ADDENDUM NO. 2

2020 AIRPORT PAVEMENT, DRAINAGE, AND FENCING IMPROVEMENTS  
TXDOT CSJ NO. 2014MASON  
MASON COUNTY AIRPORT  
MASON, TEXAS

This Addendum to the Project Manual is issued to modify, explain, or correct the original Contract Documents and Specifications for Mason County Airport 2020 Airport Pavement, Drainage, and Fencing Improvements (TxDOT CSJ No. 2014 MASON) and is hereby made part of the Contract Documents.

SHEET 12

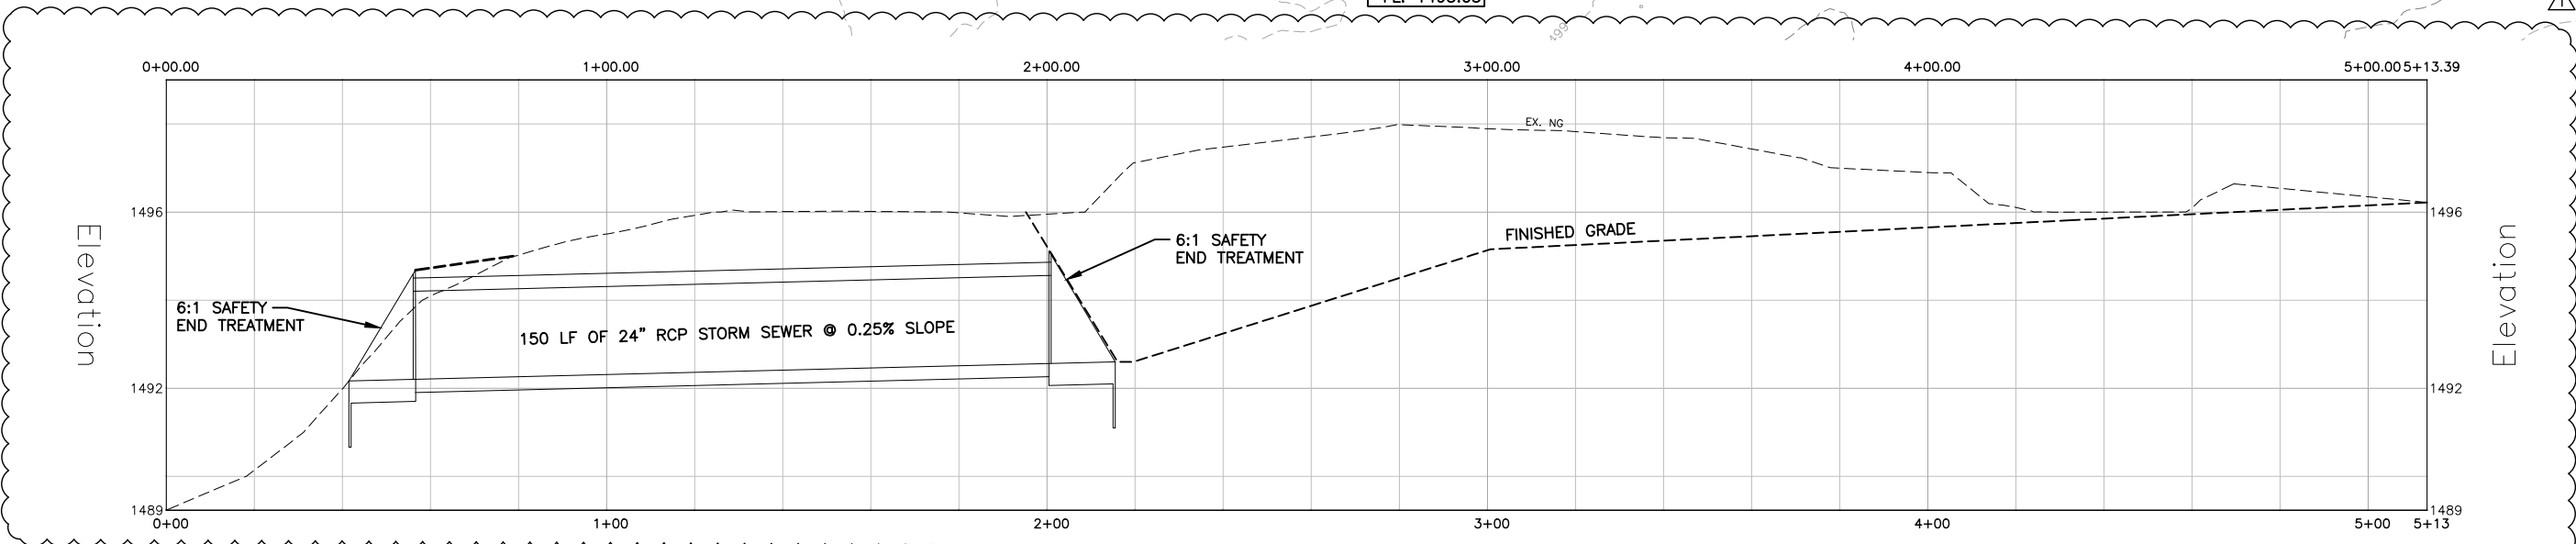
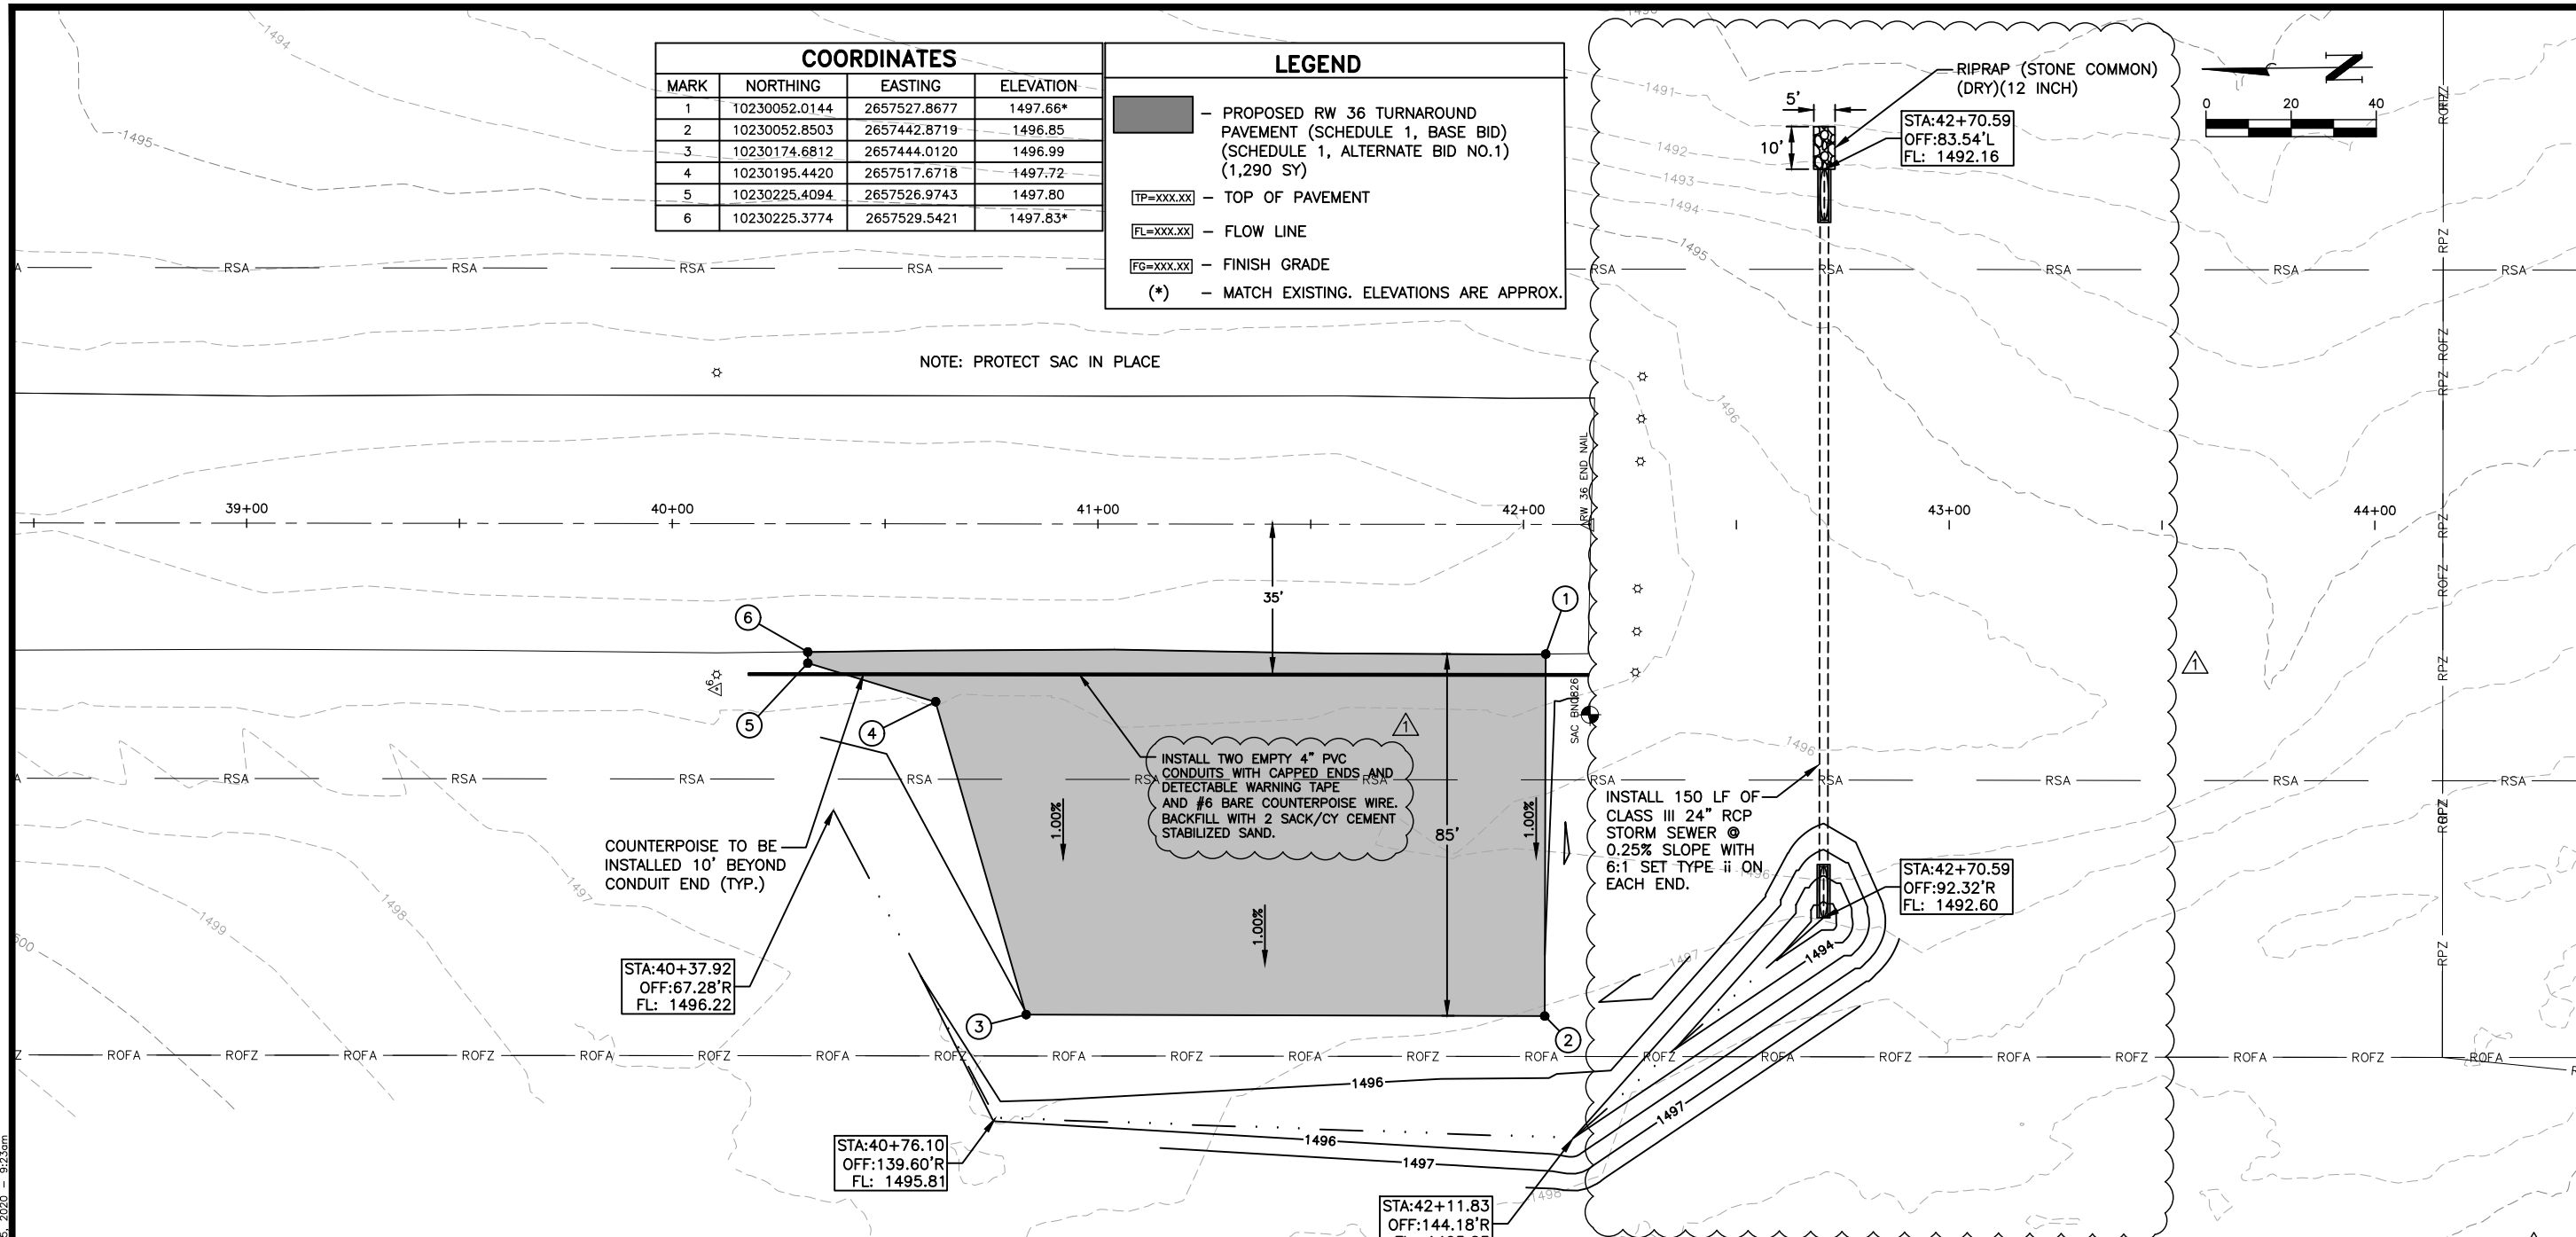
- (1) Sign-in sheet.
- (2) Prebid Conference Agenda.
- (3) Issues or clarification from the Prebid Conference.
- (4) Revised grading and added storm sewer on the RW 36 end.

**STRAND ASSOCIATES**  
**SHEET**  
 30

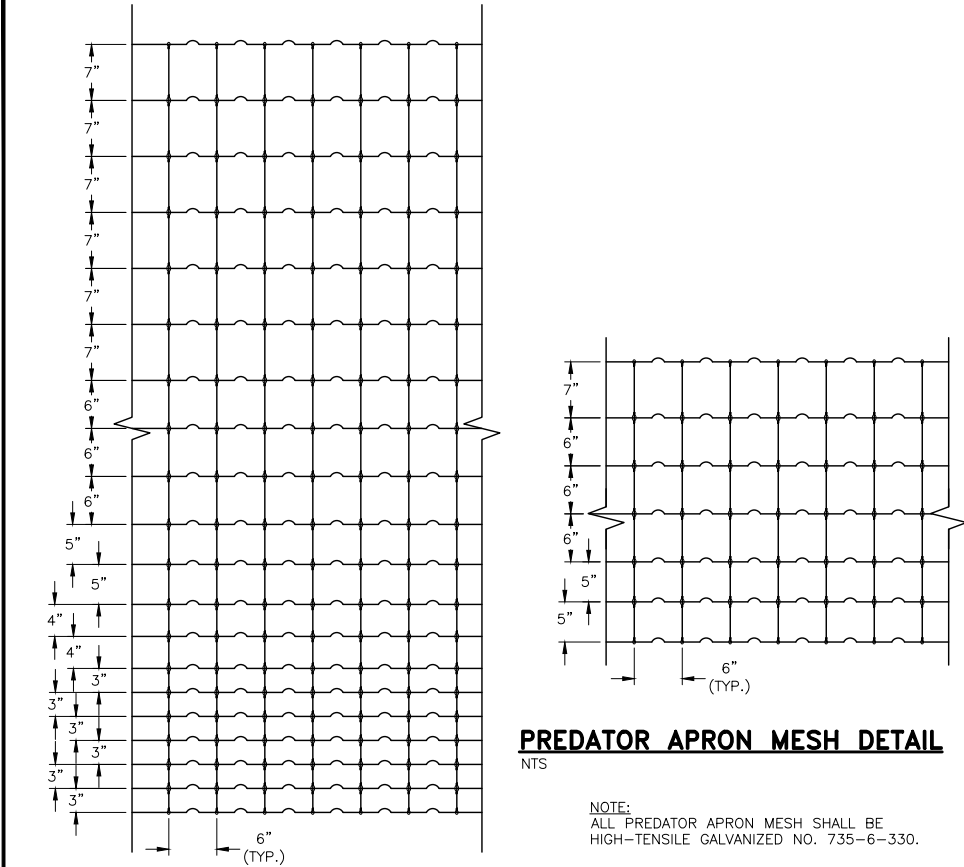
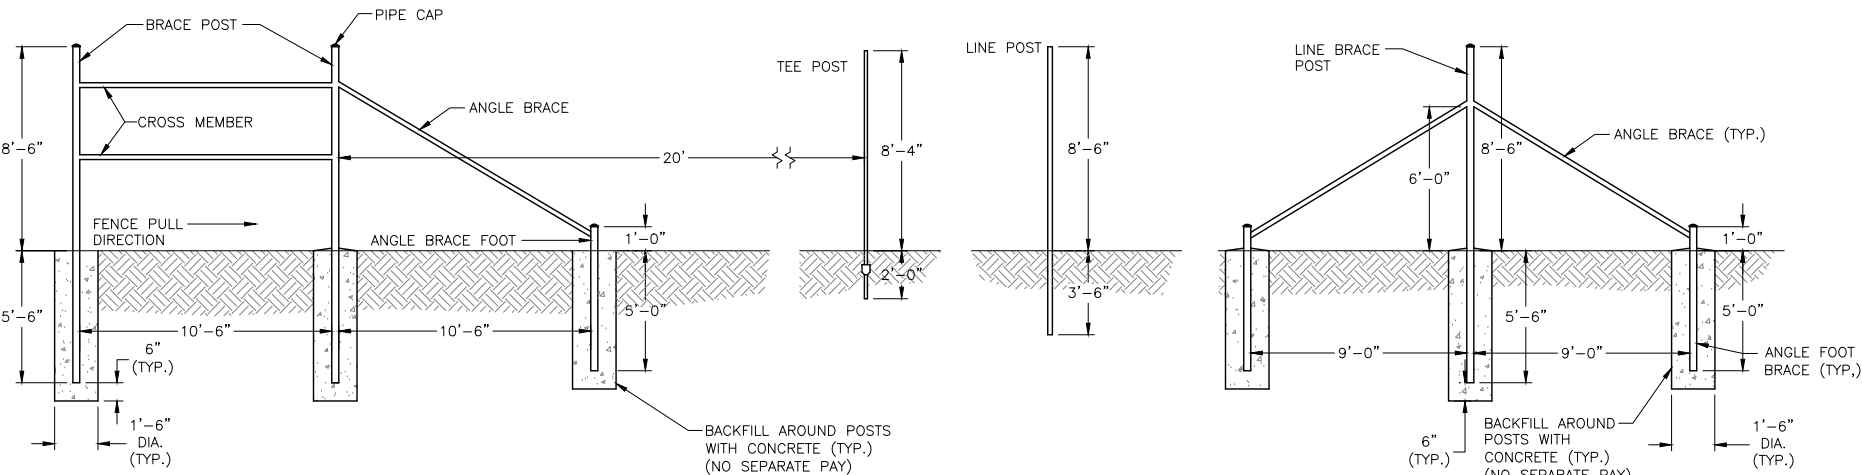
7. Drawing Sheet 30 calls for gate posts at 1320 feet minimum, is this accurate?

A callout has been included on Sheet 30 for means of securing the predator apron to the ground. See the updated sheet attached with this Addendum.

The Drawing Sheet should call for 1,320 feet MAXIMUM spacing as called for in the Specification. See the updated sheet attached with this Addendum.

**LINE BRACE NOTES:**  
 1. SPACE AT 1320' MAXIMUM WIRE BETWEEN THE TWO END BRACES. SET THE MIDDLE BRACE POST ON THIS LINE.  
 2. PULL A GUIDE WIRE BETWEEN THE TWO END BRACES. SET THE MIDDLE BRACE POST ON THIS LINE.  
 3. SET THE ANGLE BRACE POSTS 9' FROM THE BRACE POSTS ON EITHER SIDE IN LINE WITH THE FENCE LINE GUIDE WIRE.  
 4. MEASURE THE WIDTH FROM THE ANGLE FOOT BRACE (APPROX. 9" ABOVE THE GROUND) TO THE BRACE POST (APPROX 6' ABOVE THE GROUND). CUT AND SADDLE THE ANGLE BRACE AND WELD SOLID.  
 5. CAP ALL PIPE WITH CEMENT OR A PRESSED STEEL PIPE CAP. BRUSH ALL WELDS AND TREAT WITH GALV MATCH PLUS OR APPROVED EQUAL TO PREVENT RUST.
